2nd October 2008

Response to ACC Bucksburn-Kingswells Link Consultation

Figure 1 – Illuminated Cycle Path

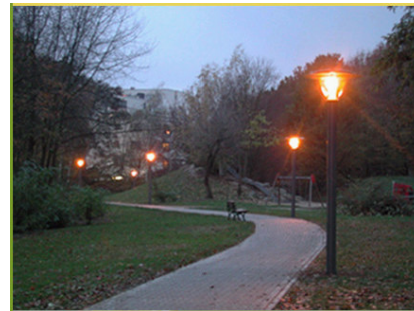
For these reasons ACF maintains that the path **should have some form of lighting**. Figure 1 shows a German example of off road cycle path lighting using standard luminaries. We see this as adequately meeting the requirements of the proposed users.
